Subject: Submittal of Response to the New Mexico Environment Department Request for Supplemental Information for the *Mixed Waste Landfill Second Five-Year Report*, Sandia National Laboratories, New Mexico, U.S. Environmental Protection Agency Identification Number NM5890110518

***Response to the New Mexico Environment Department Request for
Supplemental Information for the Mixed Waste Landfill Second
Five-Year Report***

Subject: Response to the New Mexico Environment Department Request for Supplemental
Information for the *Mixed Waste Landfill Second Five-Year Report*, Sandia National
Laboratories, New Mexico, EPA ID#NM5890110518, HWB-SNL-23-024

Figure 1
Fault Locations in Relation to the Mixed Waste Landfill and Kirtland Air Force Base

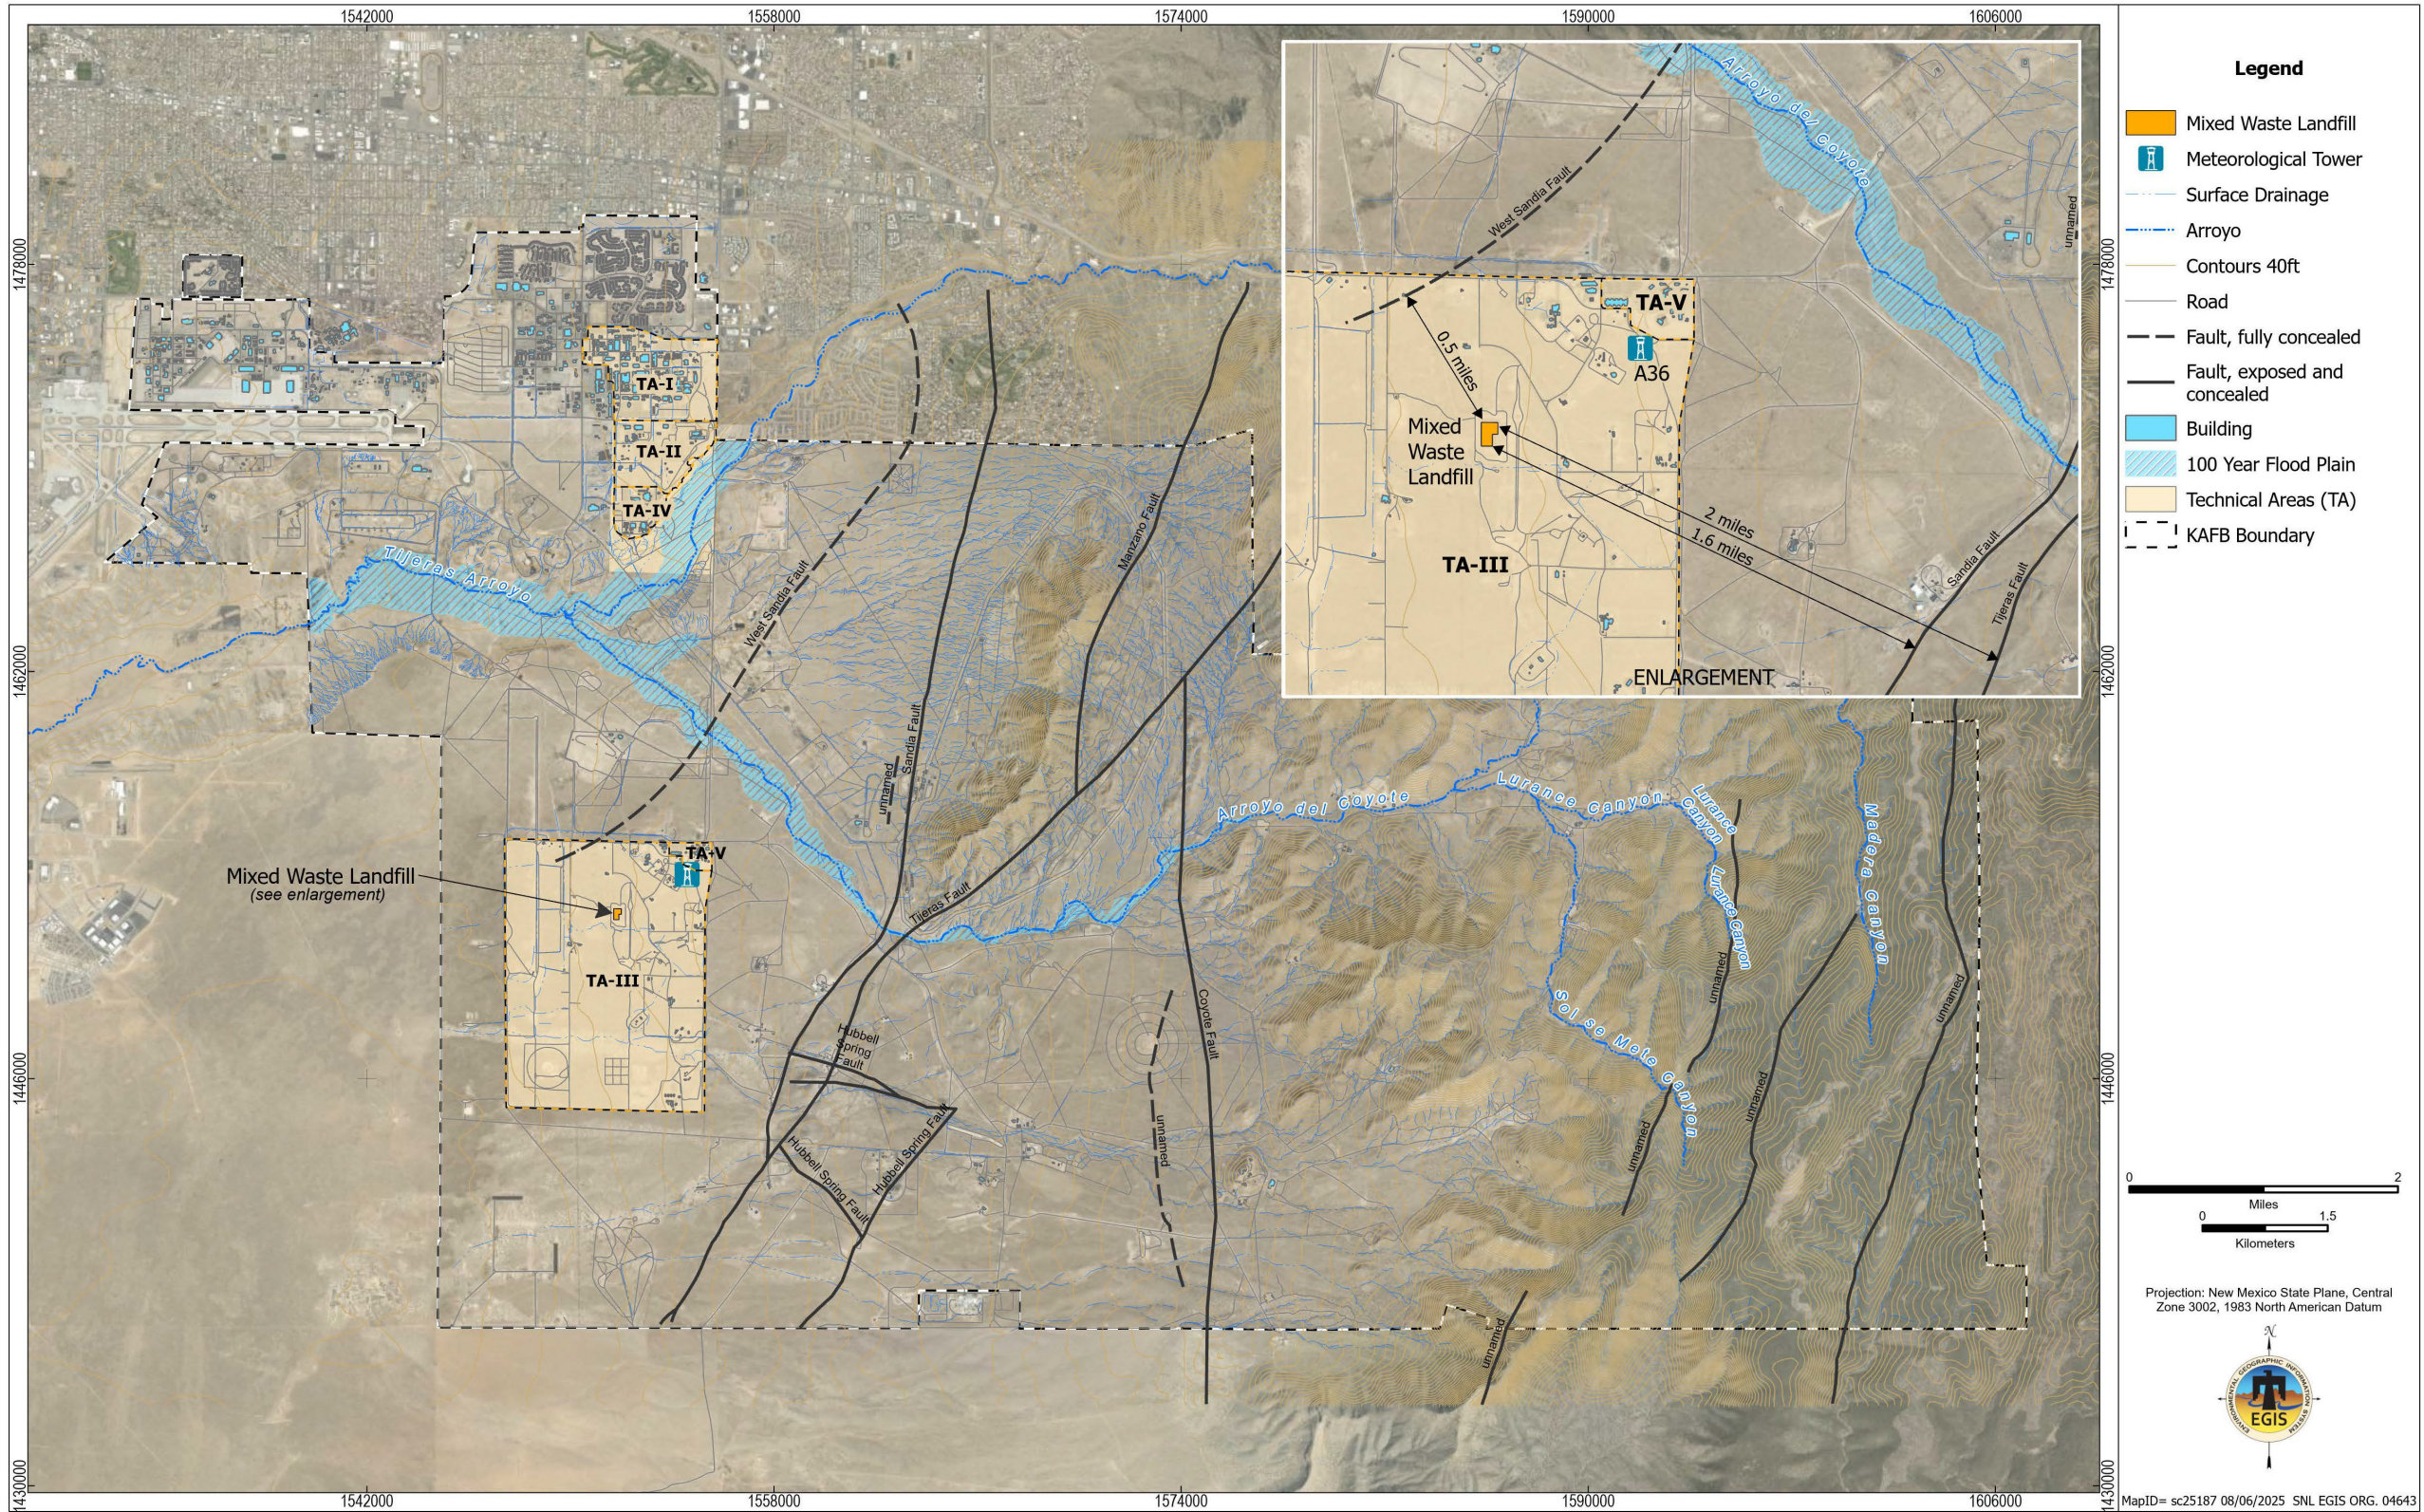
1a. Discuss the location and activity of nearby fault zones and the Rio Grande Rift in relation to the MWL.

The Mixed Waste Landfill (MWL) is located near the east-central edge of the Albuquerque Basin. The Albuquerque Basin (also known as the Middle Rio Grande Basin) is one of a series of north-south trending basins that was formed during the extension of the Rio Grande Rift. Rift formation began in the late Oligocene and continued into the early Pleistocene, with the primary period of extension occurring between 30 and 5 mega annum, or million years ago. The Rio Grande Rift extends from central Colorado to northern Mexico. While the Rio Grande Rift is associated with faulting and seismic activity, the Albuquerque area has a relatively low seismic hazard compared to other tectonically active regions in the United States.

Table 1 lists the six primary faults on Kirtland Air Force Base (KAFB), including their distances from the MWL and approximate ages. Figure 1 presents the fault locations in relation to the MWL and broader KAFB area. Due to the lack of discernible surface and subsurface expressions or displacement, the fault locations are, in most cases, estimated.

The Sandia, Tijeras, and Hubbell Spring Faults converge near the southeast end of Technical Area-III within the KAFB boundary. This complicated system of faults, which define the eastern edge of the Albuquerque Basin, are collectively referred to as the Tijeras Fault Complex. The MWL is located between the inferred West Sandia Fault to the north and the Tijeras Fault Complex to the east and southeast.
